COVER DOCUMENT

System Pillar / EULYNX

Baseline Set 4 Release 3

Version: 3.4
Date: 30-06-2025

[EUP-576] [Wrong transition condition in STM diagram](#)**[F Control And Observe 4W PM](#)**

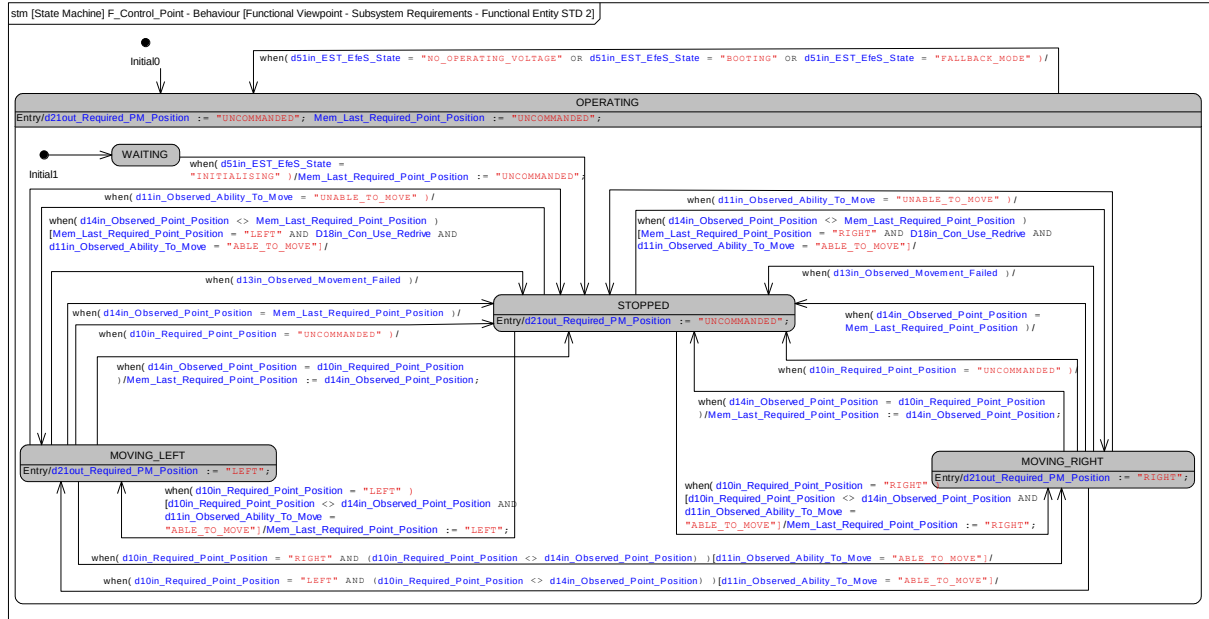
The STM diagram F_Control_And_Observe_4W_PM (Eu.P.5823) contains an error.

The 2nd transitions from MOVING_LEFT_PM / MOVING_RIGHT_PM to DETECTION contain d12in_Required_PM_Position = "LEFT_REACHED" /

d12in_Required_PM_Position = "RIGHT_REACHED"

This condition can never be true, because the values "LEFT_REACHED" /

"RIGHT_REACHED" are not used for the port d12in_Required_PM_Position.

The correct transition must be d27in_4W_PM_Position = "LEFT_REACHED" / d27in_4W_PM_Position = "RIGHT_REACHED".

The correct transitions are shown in the attached figure.

Attachments:	 Figure SDI-IO multiplicity corrections.png
--------------	--

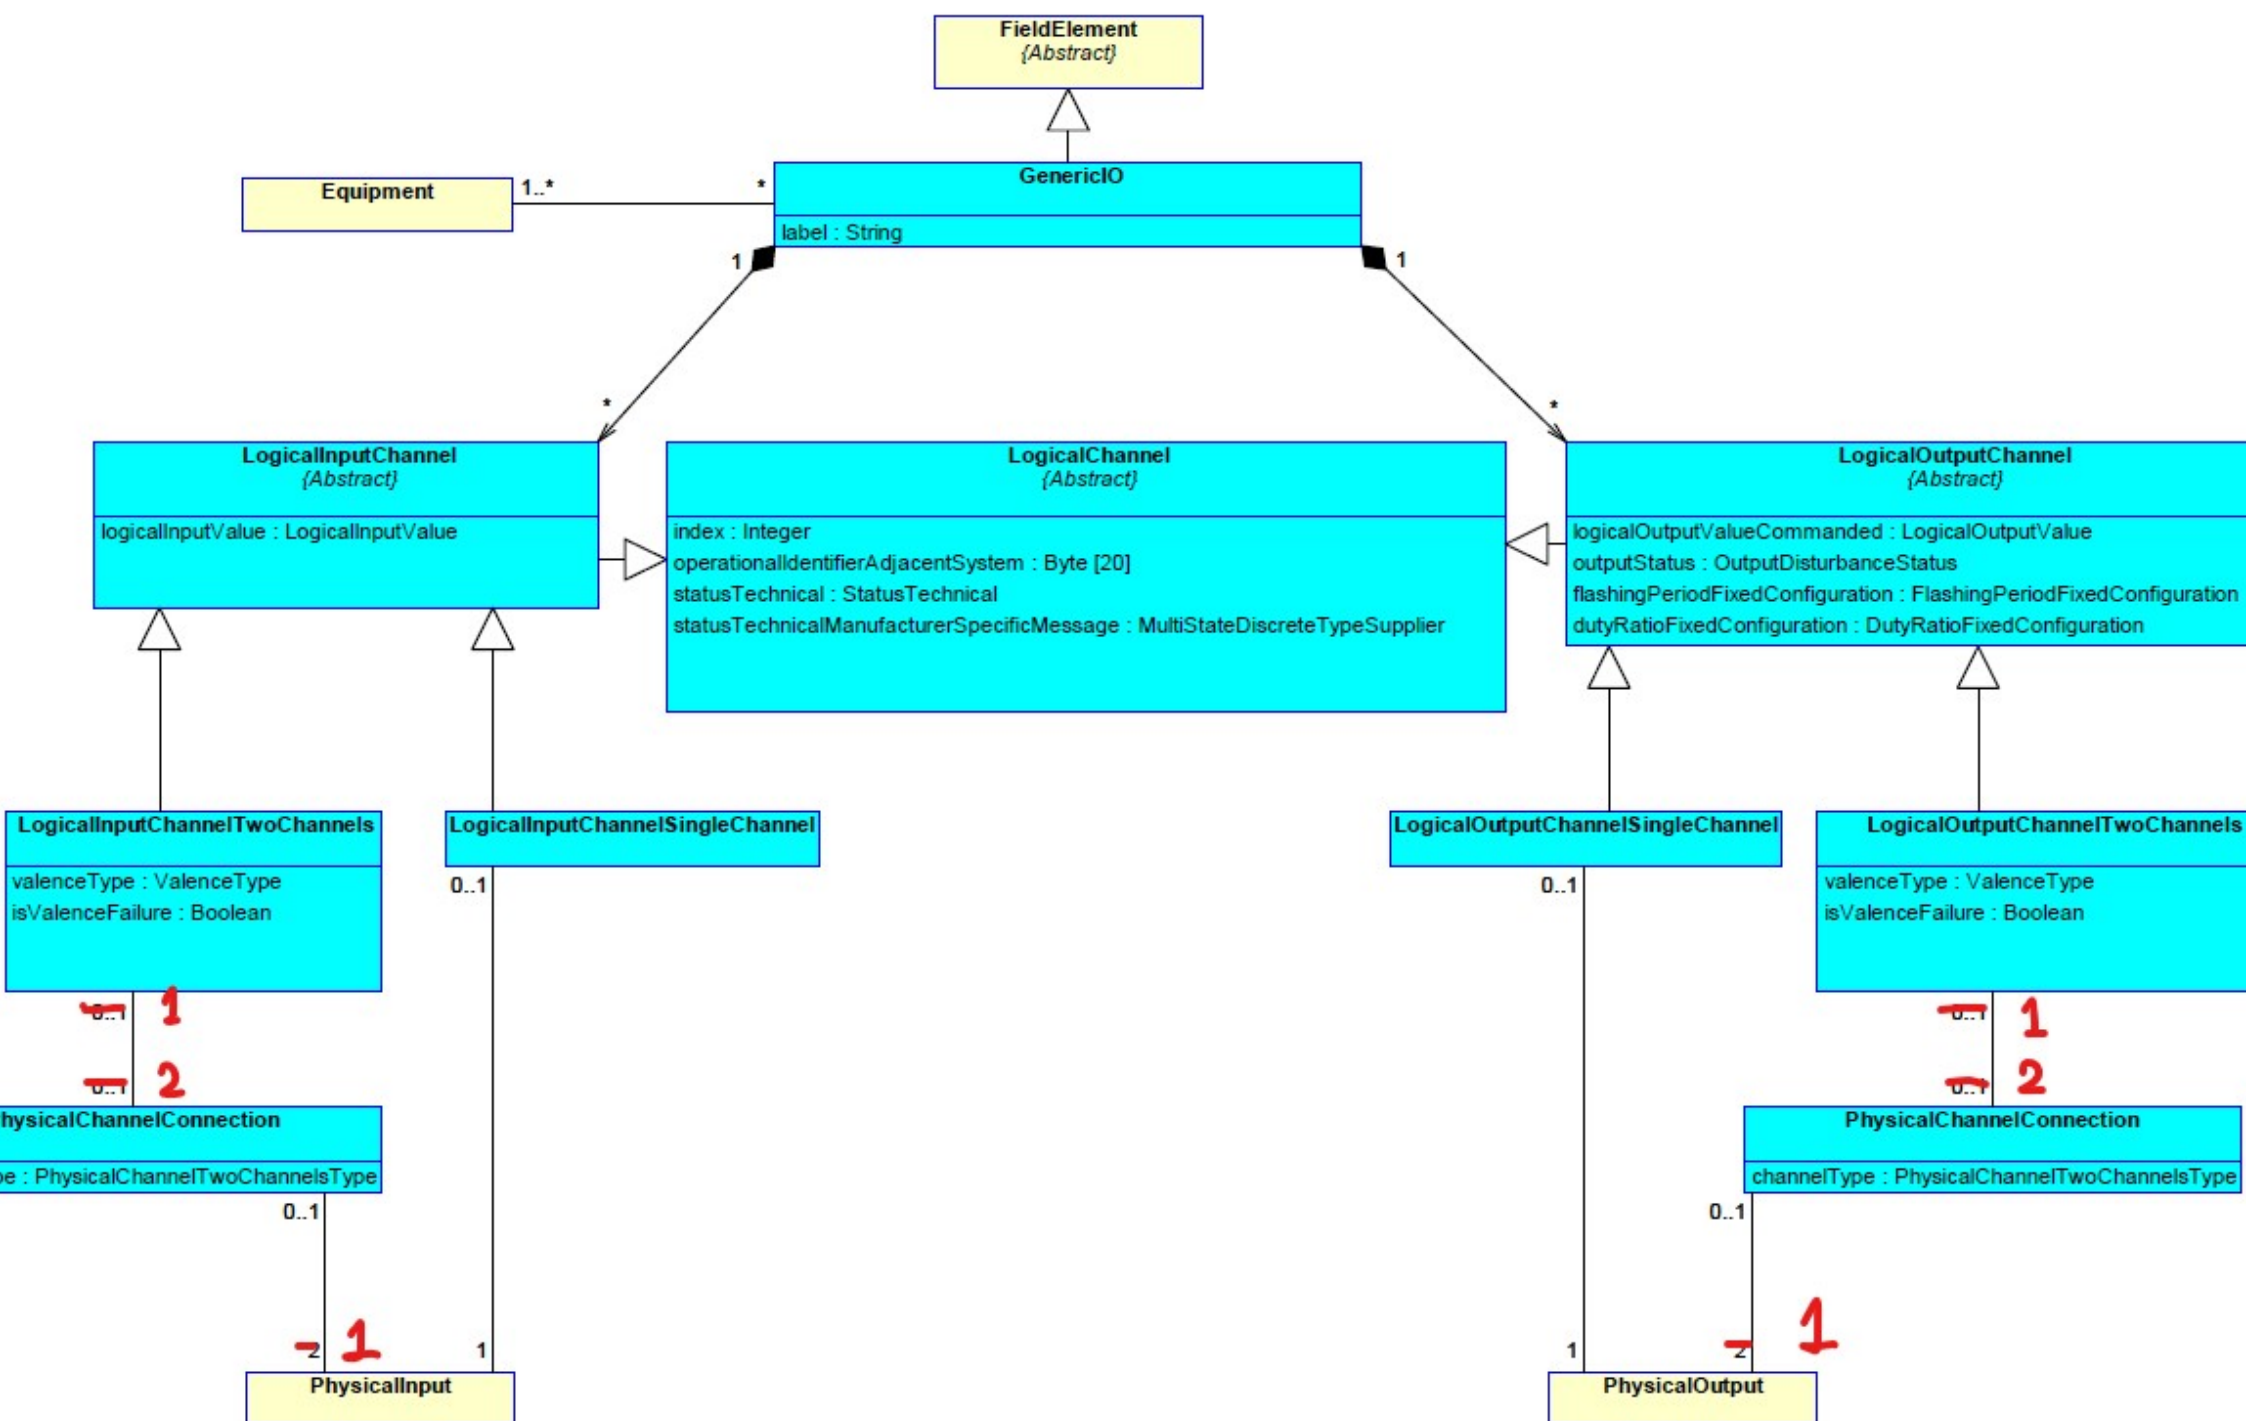
Problem
The multiplicities between LogicalInputChannelTwoChannels, PhysicalChannelConnection and PhysicalInput are incorrect.
Also valid for the multiplicities between LogicalOutputChannelTwoChannels, PhysicalChannelConnection and PhysicalOutput.

Intended state
See figure.

ibd [Block] F_SMI_EfeS [Functional Viewpoint - Interface Requirements - Functional Entity]

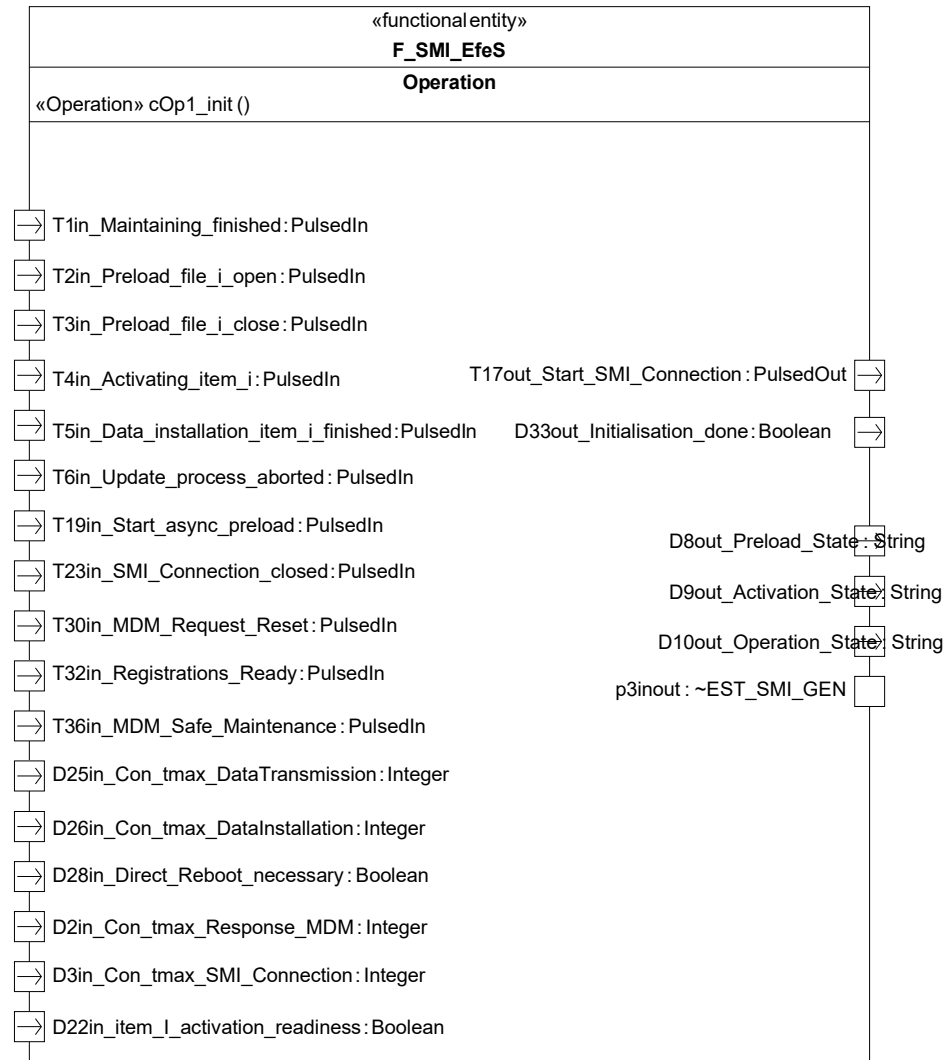
Notes:
Current State: BL4R3
Problem Description: PILZ raised that the reaction D10out_Operation_State = "NotMaintenance" is missing at the transitions going out of Data_Update. This means that the value of D10out_Operation_State is not defined in the state SMI_CONNECTION_ESTABLISHED, it can be either "NotMaintenance" or "Maintenance". This unclarity is not intended, the value must be "NotMaintenance". With this correction, the value of D10out_Operation_State will always be "NotMaintenance" in case the state DATA_UPDATE is entered because of the trigger T19in_Start_async_preload. This fact can be used as condition to allow Activation of a configuration item (only allowed in "Maintenance". In this way, the reference to the EST_EfeS_init_SubState is no longer needed.
Proposed Solution: Add D10out_Operation_State = "NotMaintenance" in 3 transitions going out of the state DATA_UPDATE. In the transition from MDM_INTERACTION_FOR_ITEM_I to ACTIVATING, delete the condition d52in_EST_EfeS_init_SubState = "WAITING_FOR_DATA_UPDATE" and replace it with D10out_Operation_State = "Maintenance". The port d52in is no longer needed.

Add D10out_Operation_State = "NotMaintenance" in 3 transitions going out of the state DATA_UPDATE.

In the transition from MDM_INTERACTION_FOR_ITEM_I to ACTIVATING, delete the condition d52in_EST_EfeS_init_SubState = "WAITING_FOR_DATA_UPDATE" and replace it with D10out_Operation_State = "Maintenance". The port d52in is no longer needed.

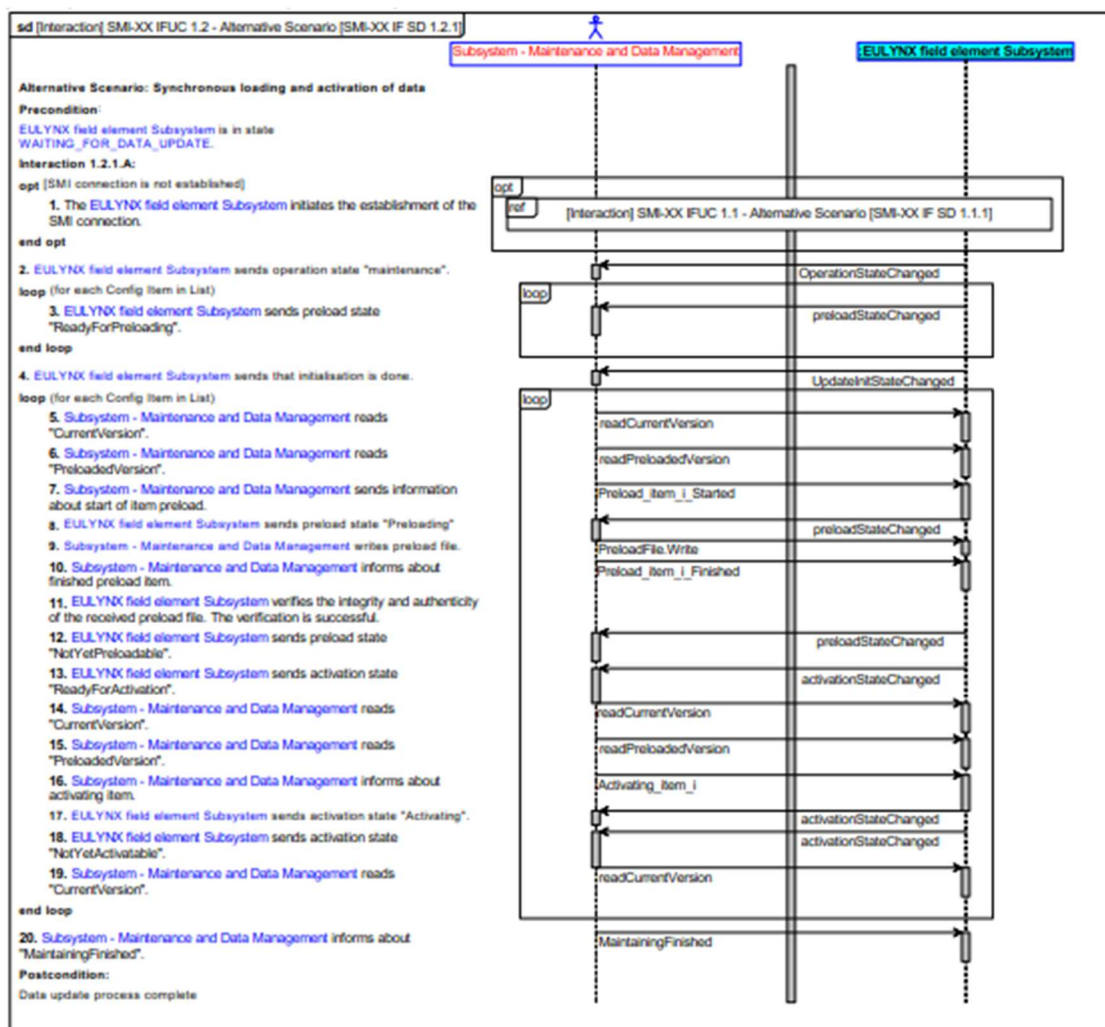
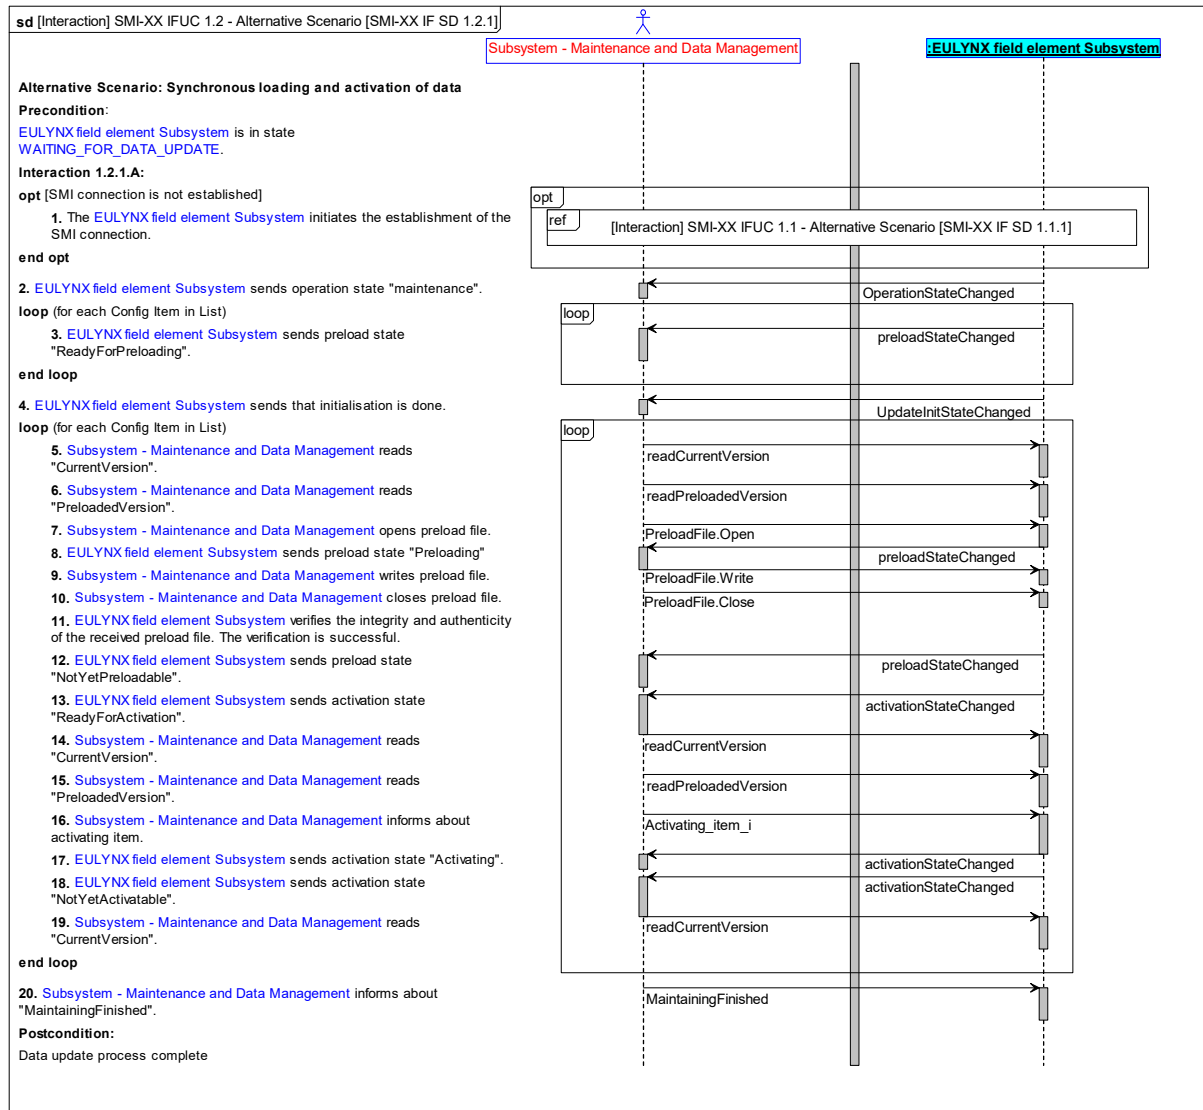
A. Technical changes in the specifications:
[Eu.Doc.120]
1. In several SDs, the arrow Preload_item_i_Started must be replaced with PreloadFile.Open. With description:
Subsystem - Maintenance and Data Management
~~sends information about start of item~~
opens preload file.
Eu.Gen-SMI.46, .47, .50

~~sends information about start of item~~

opens preload file.

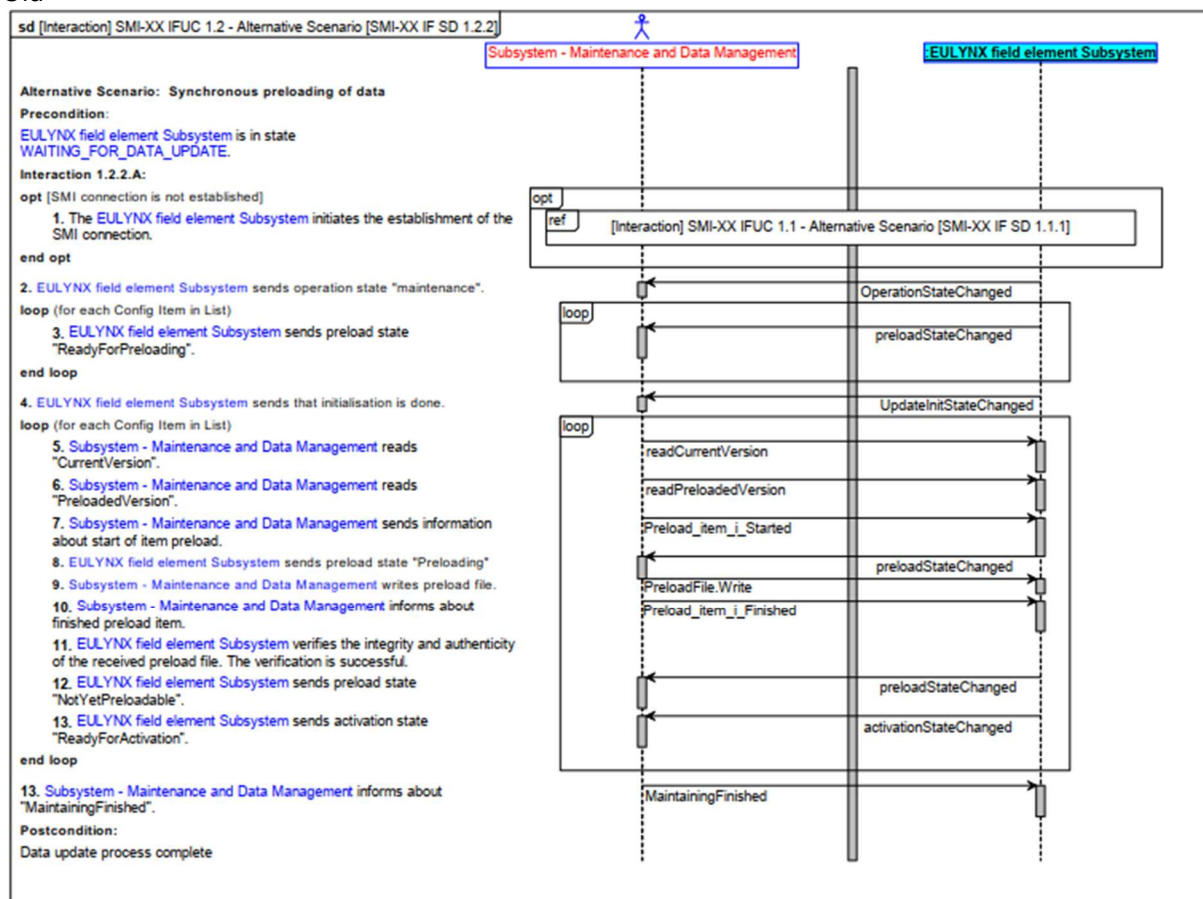
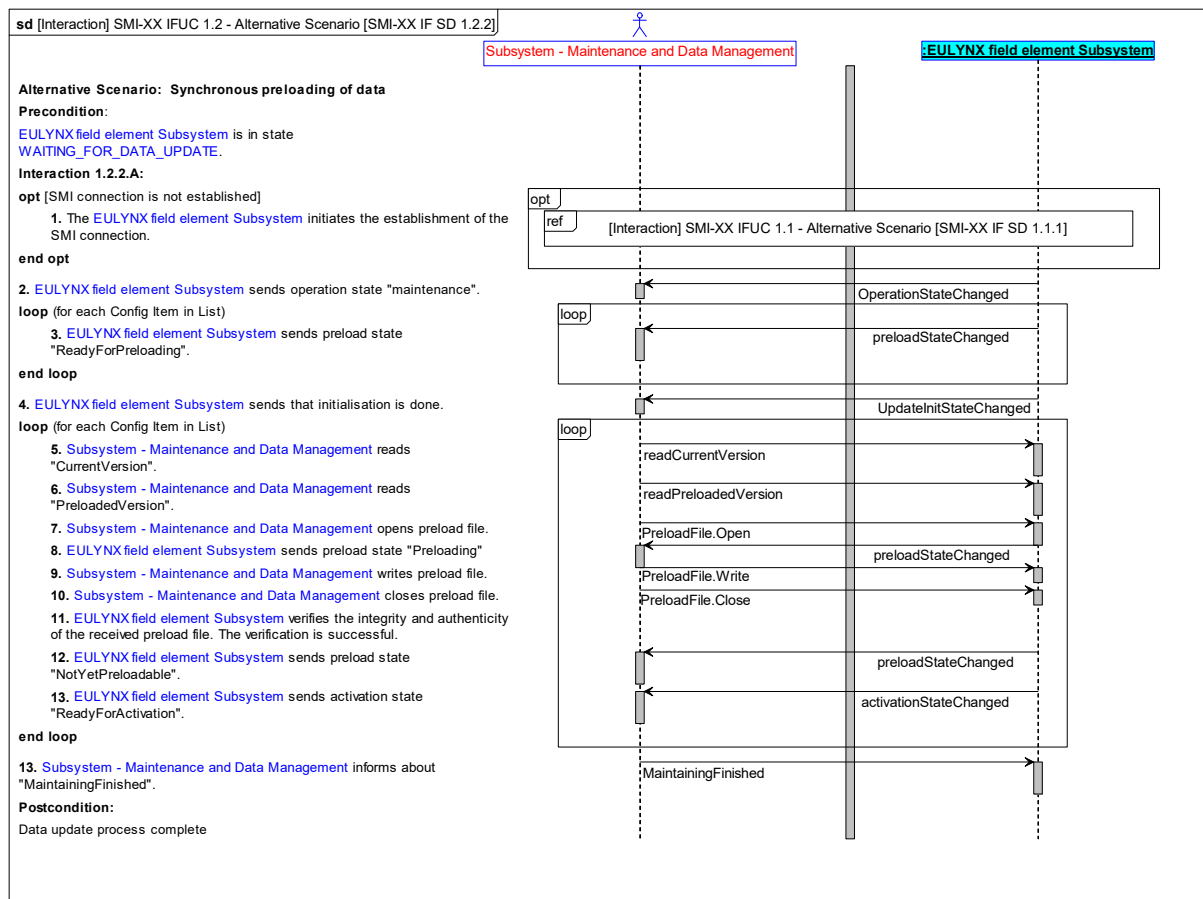
2. In several SDs, the arrow Preload_item_i_Finished must be replaced with PreloadFile.Close. With description:
Subsystem - Maintenance and Data Management
~~informs about finished~~
closes preload file
